STATEMENT OF ENVIRONMENTAL EFFECTS

**SECTION 4.56 APPLICATION TO MODIFY CONSENT GRANTED TO
DEVELOPMENT APPLICATION DA2021/1408 FOR DEMOLITION OF EXISTING
DETACHED DWELLING AND ERECTION OF A PART 2/PART 3-STOREY
DETACHED DWELLING, CARPORT, BOATSHED, SITE WORKS AND
LANDSCAPING**

**16 ADDISON ROAD
MANLY**

**Prepared by
KN Planning Pty Limited**

ROOF PLAN 1:50

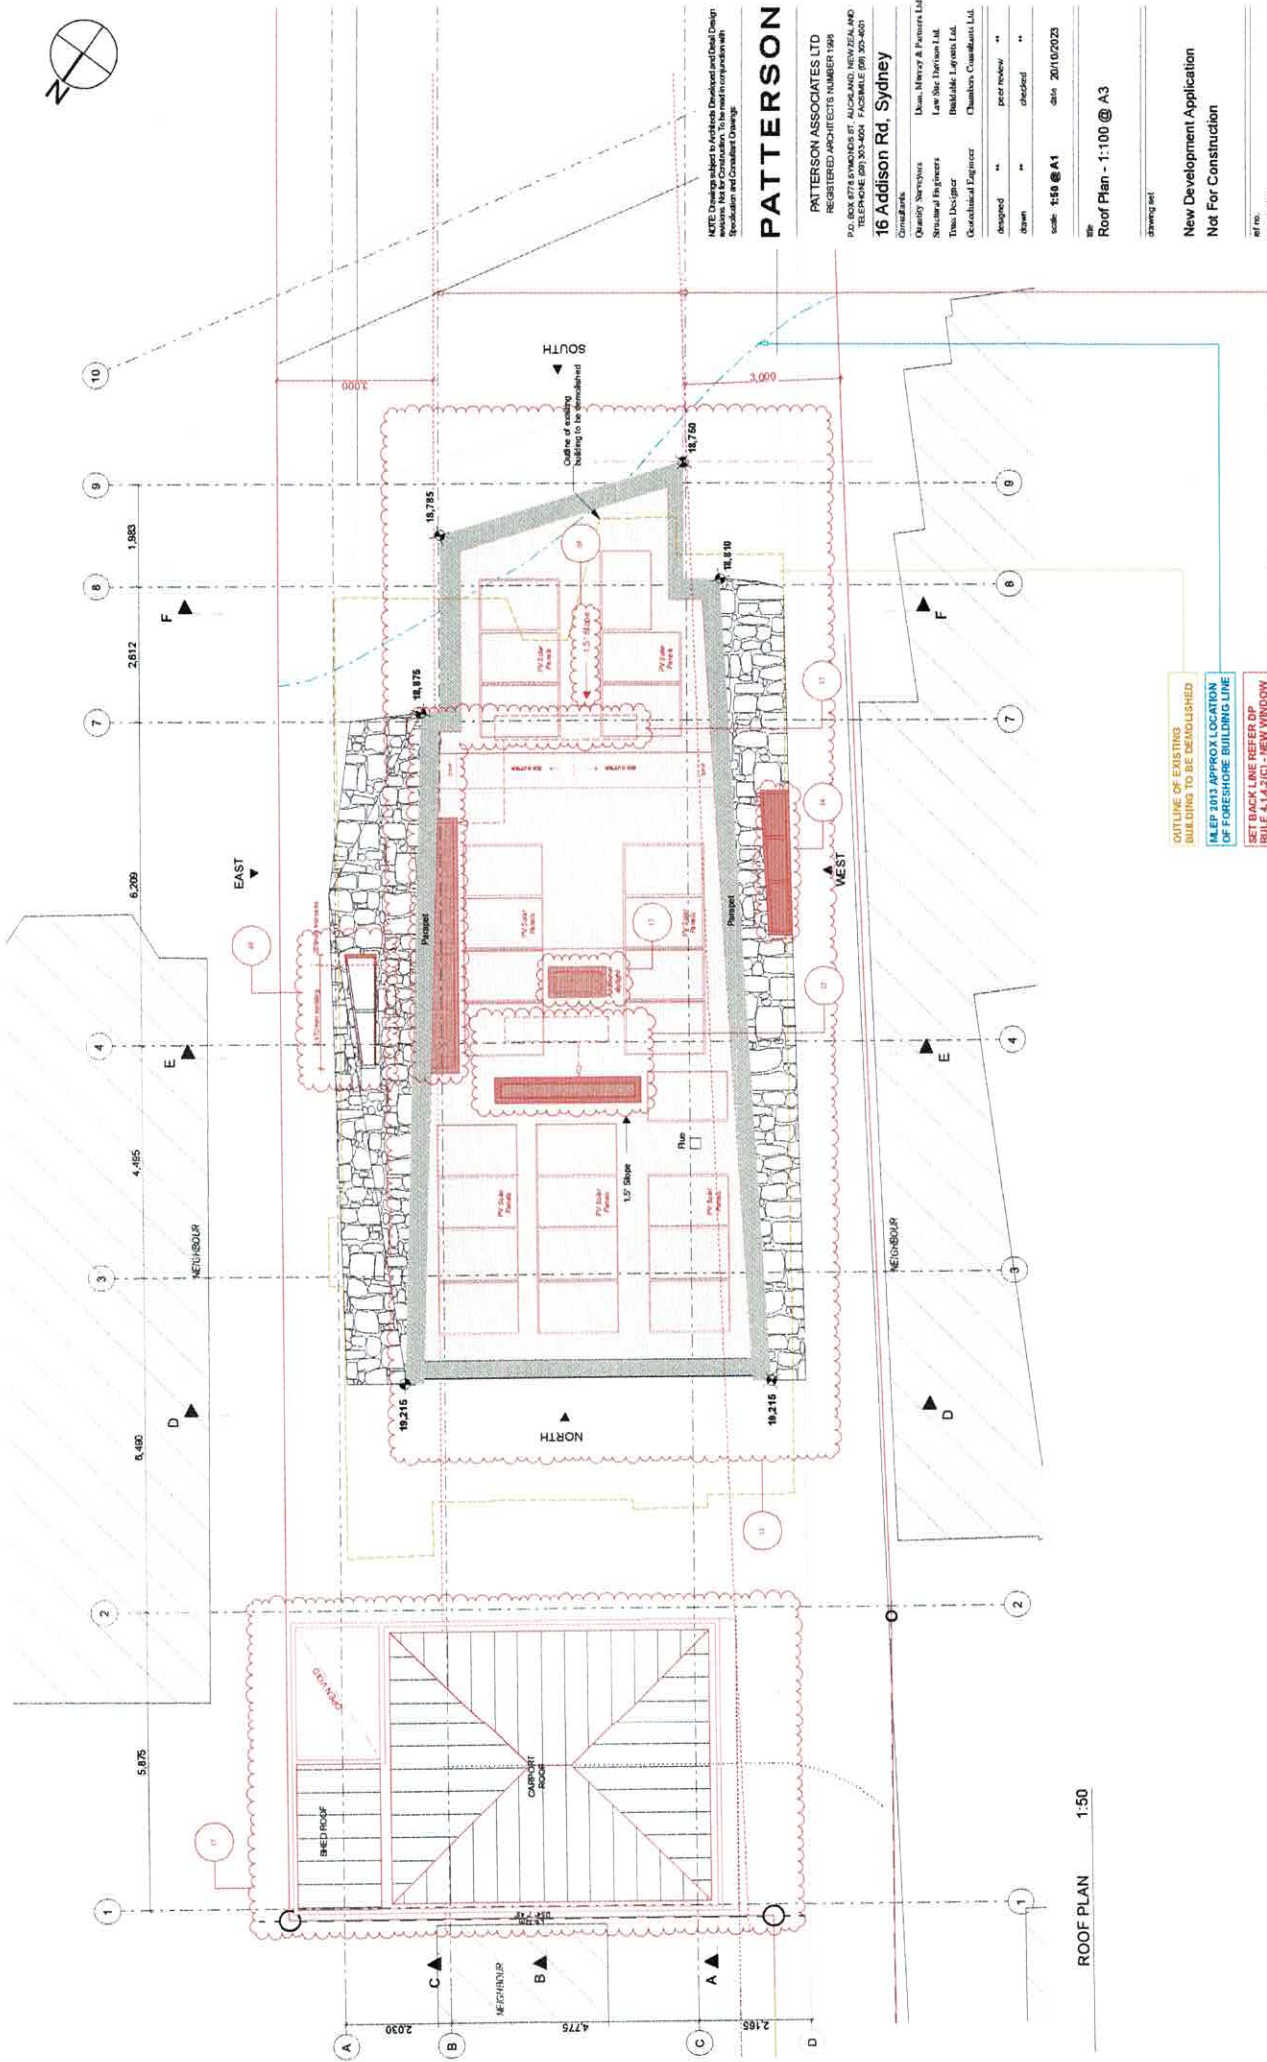
- 05. Direction of roof slope adjusted between grids 7 and 9 to suit gutter design and roof drainage.
- 10. East facade skylight widened by approx. 200mm.
- 11. PV solar panels added to roof.
- 12. Relocated skylight in roof over master ensuite bathroom 1 and hallway.
- 13. Additional skylight in roof added over master robe.
- 14. Relocated skylight to stairwell in west façade. Remains same size.
- 17. Carport roof level raised slightly to allow adequate height clearance from slab level.

sheet no. 18010
 rev. A
 3.1

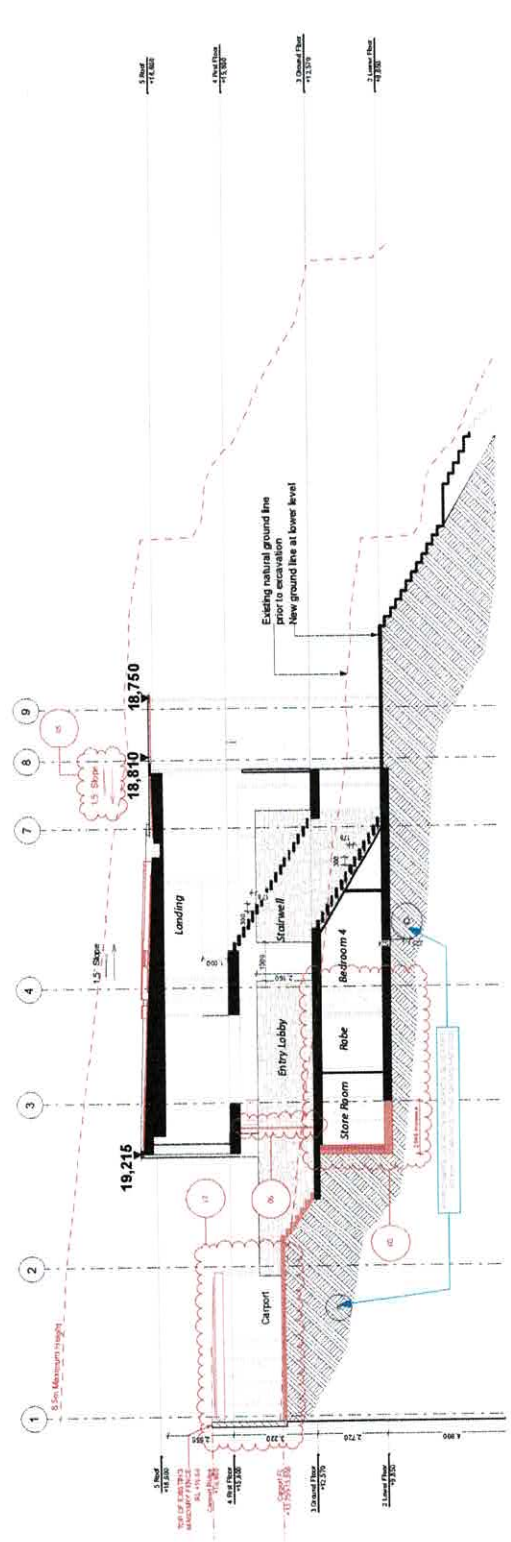
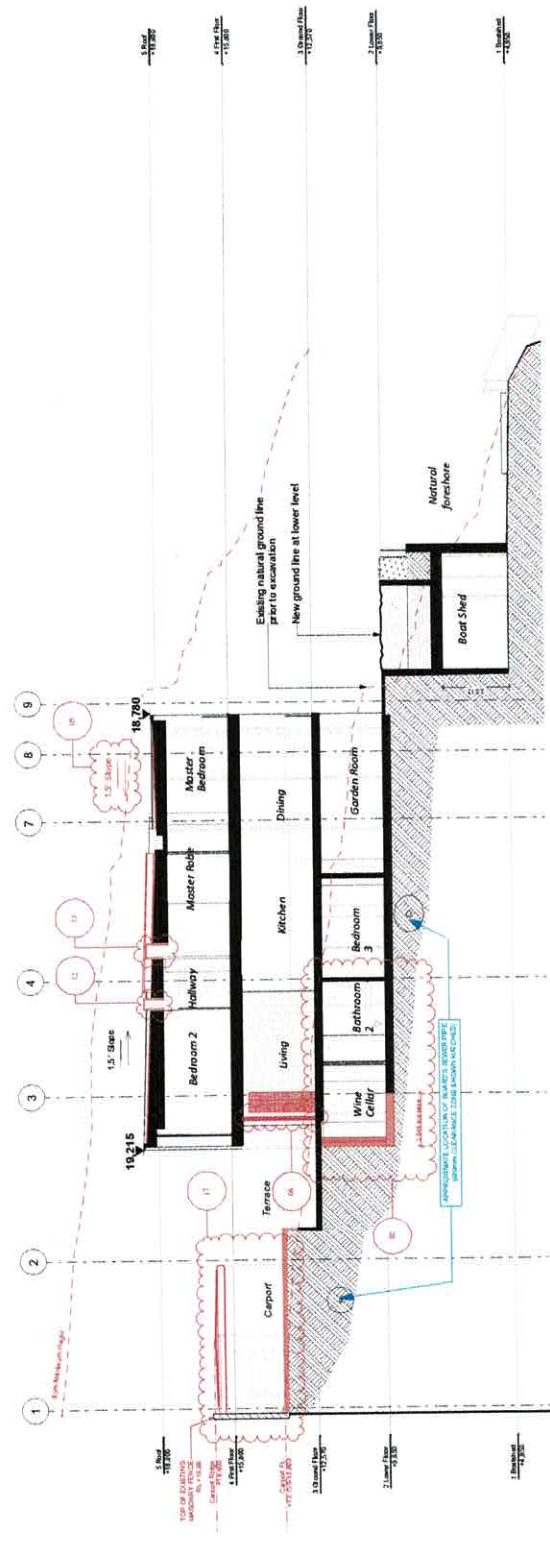
02. Basement excavation extended by 2046mm to the north to allow for additional plant equipment & store area, ensuite layout altered.

05. Direction of roof slope adjusted between grids 7 and 9 to suit gutter design and roof drainage.

06. The sliding glazed doors accessing the north terrace have been moved approx. 1.0m north to allow for a WC on the ground floor. The front door was moved to align with the sliding doors.

12. Relocated skylight in roof over master ensuite bathroom 1 and hallway.

13. Additional skylight in roof added over master robe.

17. Carport roof level raised slightly to allow adequate height clearance from slab level.

Sheet No: 180/10
 Rev: A
 3.2

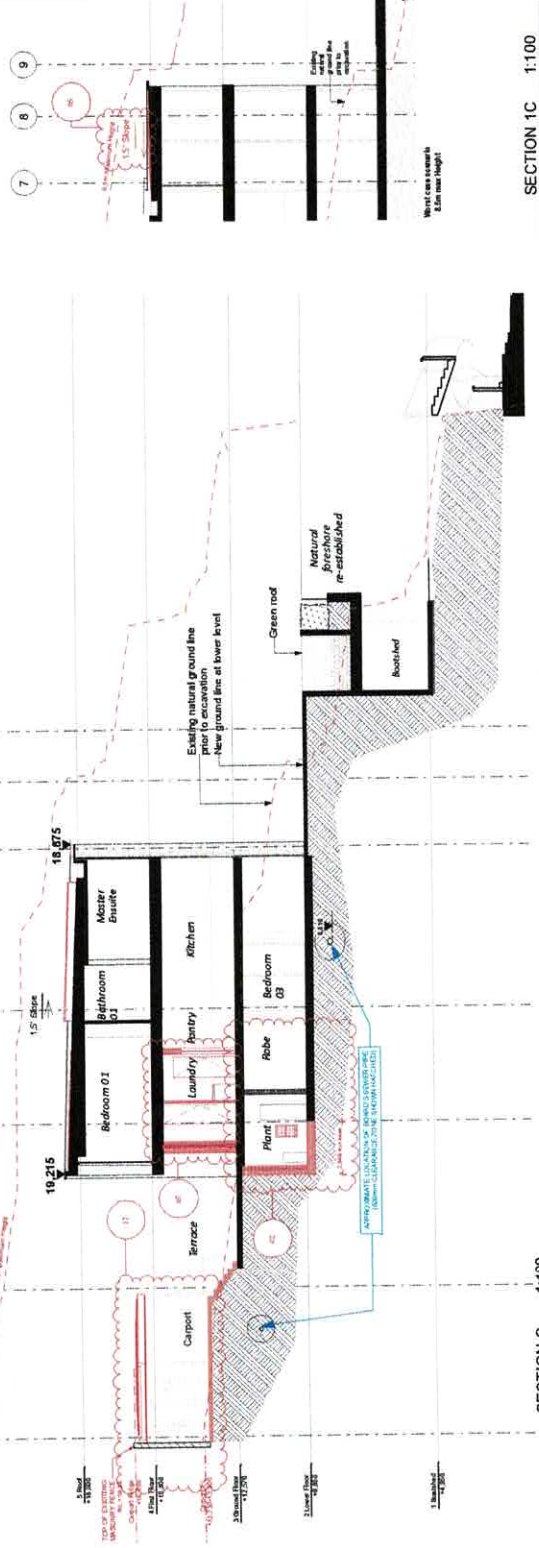
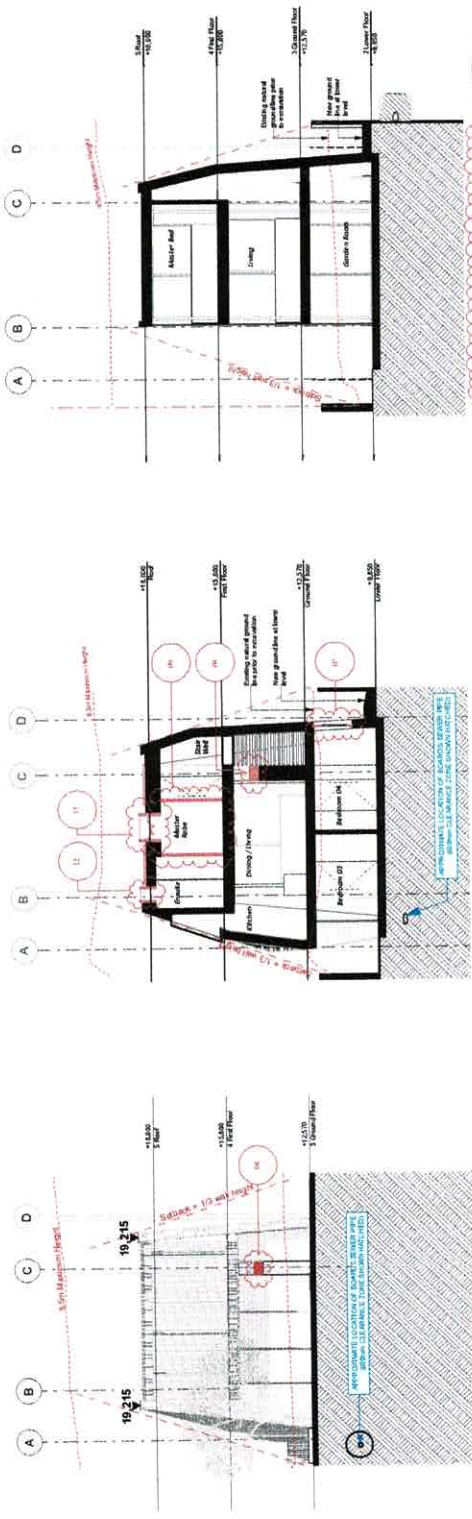
02. Basement excavation extended by 2046mm to the north to allow for additional plant equipment & store area, ensuite layout altered.

03. Window to bedroom 04 in western façade increased in length by 1.0m and 0.5m in height.

04. Increase height of interior rock wall by 400mm.

05. Direction of roof slope adjusted between grids 7 and 9 to suit gutter design and roof drainage.

07. The metal clad wall on grid A was extended to the north to provide additional area for the WC.

09. Alterations to internal planning of bathroom, ensuite & robe.

12. Relocated skylight in roof over master ensuite and bathroom 1.

13. Additional skylight in roof added over master robe.

17. Carport roof level raised slightly to allow adequate height clearance from slab level.
